CEQA ADDENDUM DATED OCTOBER 31, 2008

**FINAL ADDENDUM
DATED OCTOBER 31, 2008
TO THE CAMINO REAL ENVIRONMENTAL IMPACT REPORT (96-EIR-003)
CAMINO REAL HOTEL PROJECT
401 STORKE ROAD; APN 073-440-019
CASE NO. 07-208-SP, -DP**

Responses to Comments Received

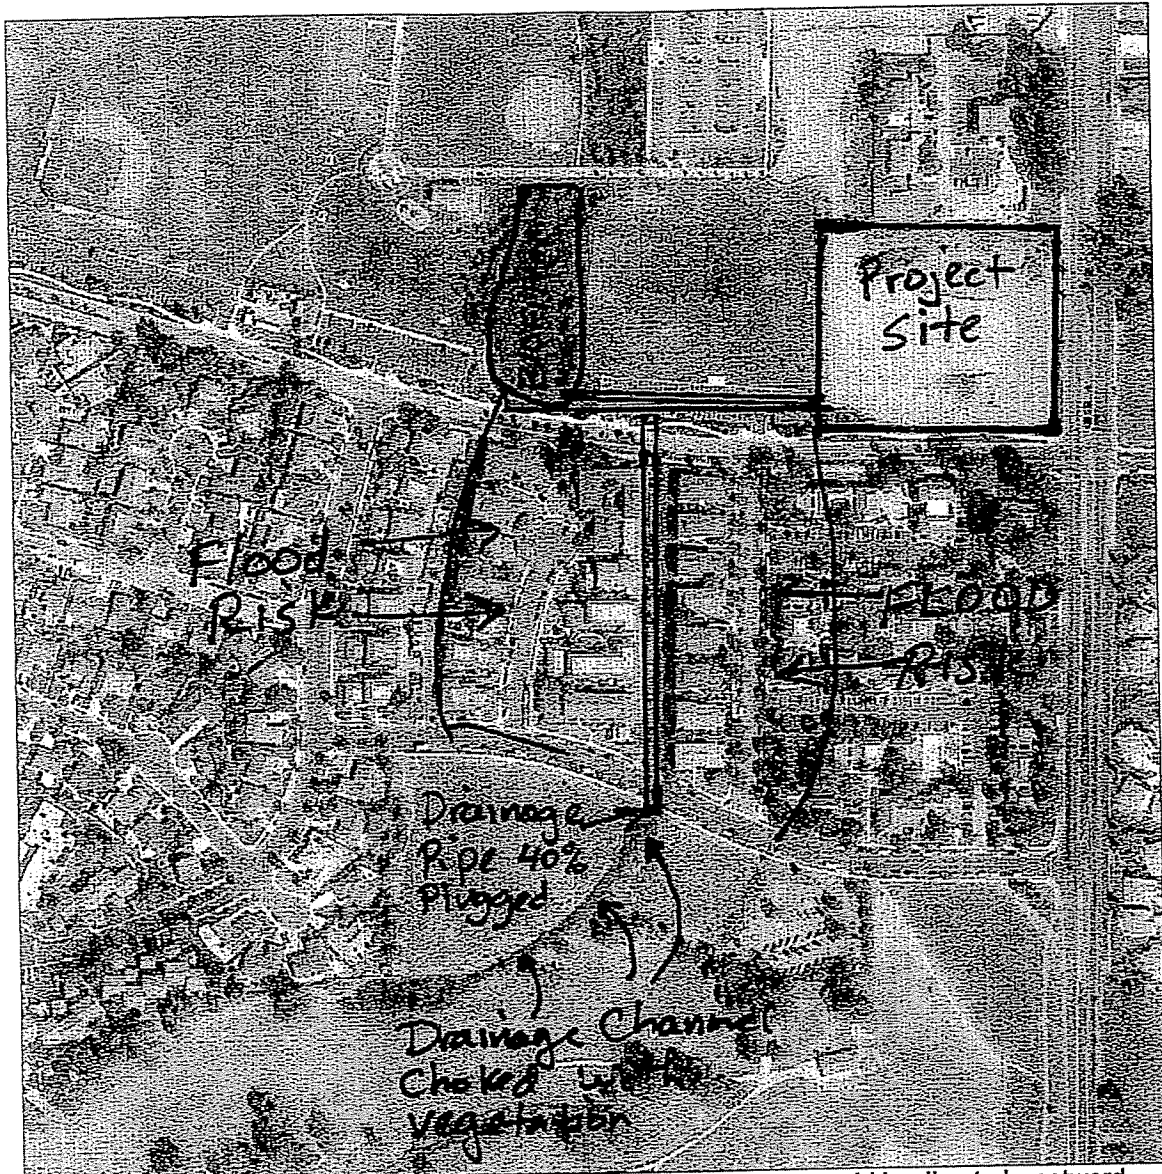
Surface water flow is proposed to be concentrated on the project site and then moved off-site to the west. Figure 1. Overview of Storm Water Drainage System. Surface water would be directed westward (towards the left) into the biofilter basin. Floodwater exits the basin and flows into a storm drain beneath Phelps Road. The water moves southward from beneath Phelps Road and discharges south of Whittier Drive, as a storm drain outlet into a drainage channel.

Figure 5-Cross-Section thru storm drain discharge point. The section shows water is pounded in the pipe because excessive soil and vegetation, and causes a mosquito-rich environment.

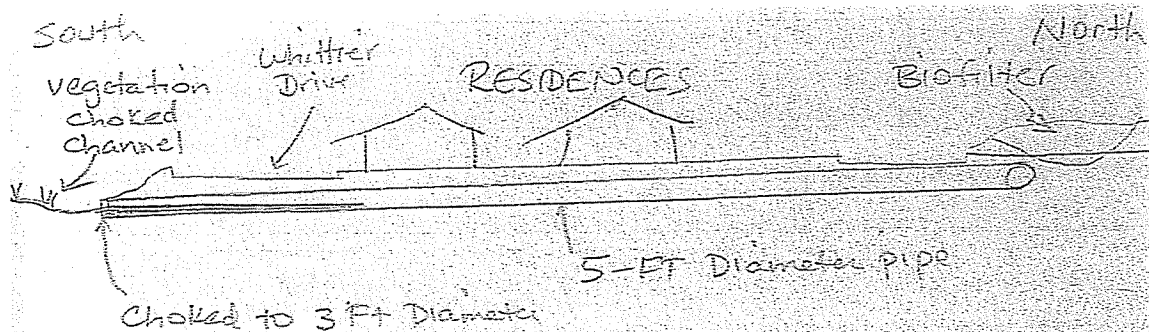
C-6 The view thru the discharge pint is shown on Figure 5-Cross-Section thru storm drain discharge point. The section shows how water is pounded in the pipe because excessive soil and vegetation in the storm drain channel. The channel has apparently accumulated significant sediment from the biofilter upstream in Girsh Park.

C-6: Community Services staff has not determined that increased sedimentation is due to the bio-filter in Girsh Park. However, Community Services staff is continuing to work with the applicant in evaluating drainage facilities for development throughout the Camino Real Specific Plan area and to coordinate with other agencies to address drainage issues, including accumulation of sediment in drainage infrastructure in areas such as those identified in this comment letter. Also, see response to comment C-2.

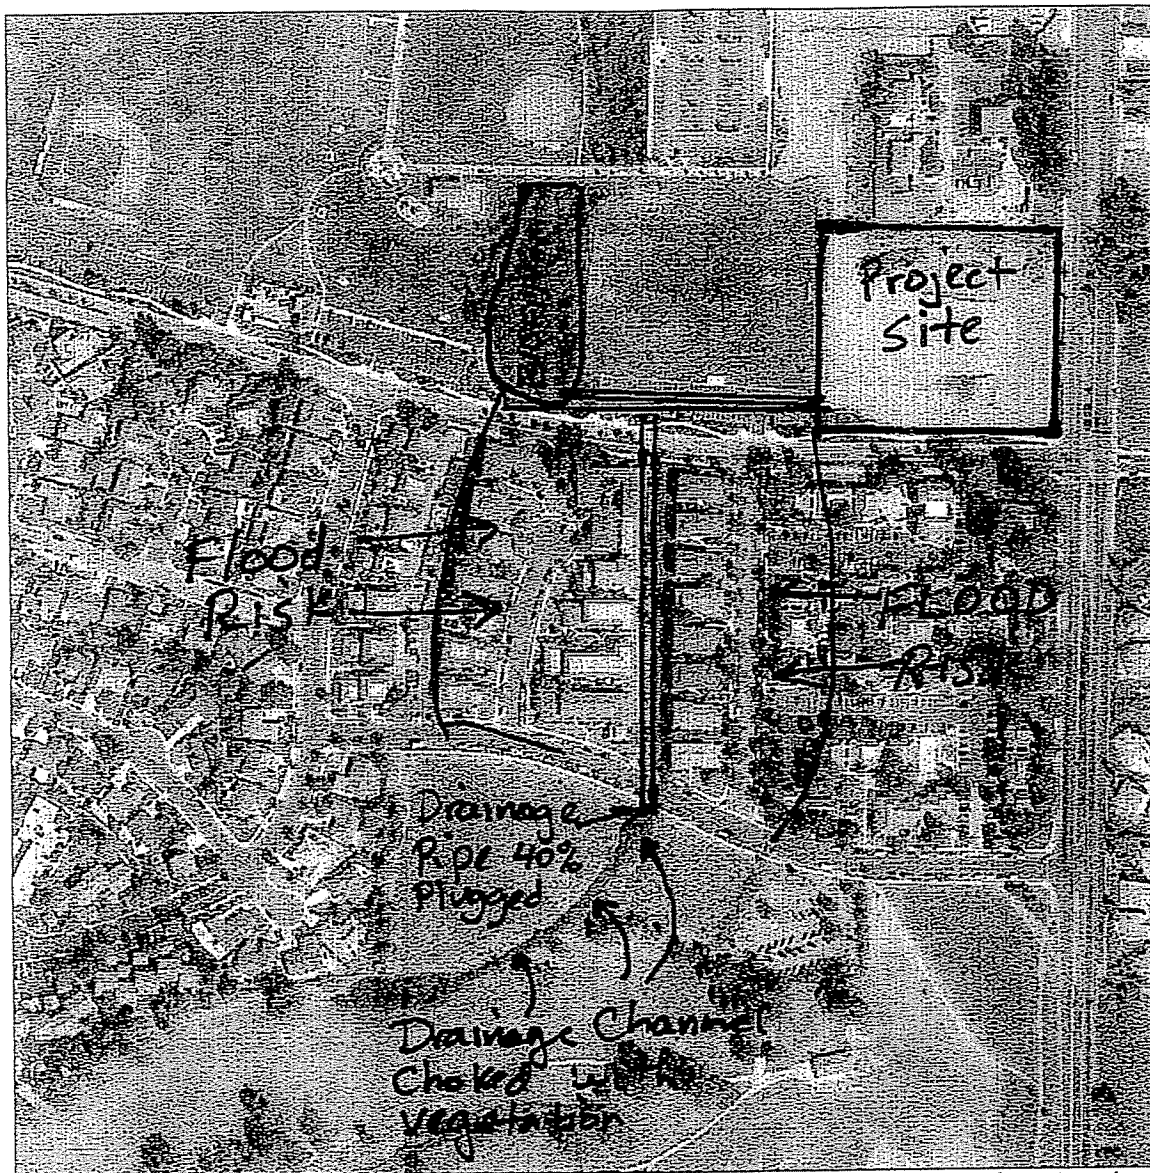
Surface water flow is proposed to be concentrated on the project site and then moved off-site to the west. Figure 1. Overview of Storm Water Drainage System. Surface water would be directed westward (towards the left) into the biofilter basin. Floodwater exits the basin and flows into a storm drain beneath Phelps Road. The water moves southward from beneath Phelps Road and discharges south of Whittier Drive, as a storm drain outlet into a drainage channel.

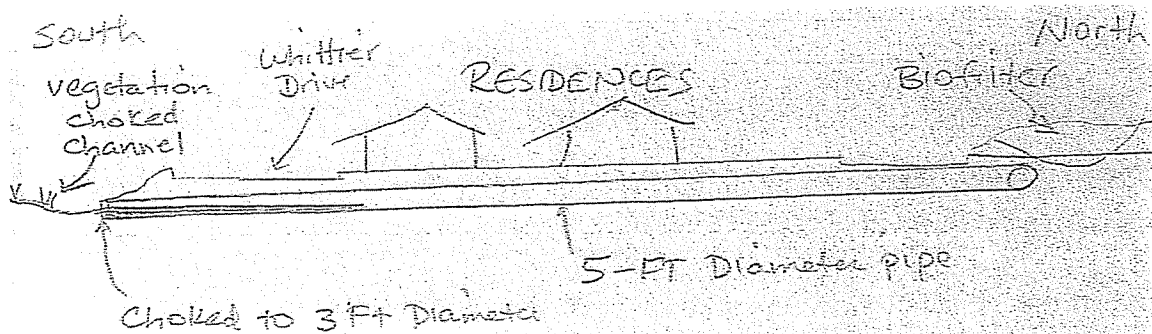
The view thru the discharge pint is shown on Figure 5-Cross-section thru storm drain discharge point. The section shows how water is pounded in the pipe because excessive soil and vegetation in the storm drain channel. The channel has apparently accumulated significant sediment from the biofilter upstream in Girsh Park.
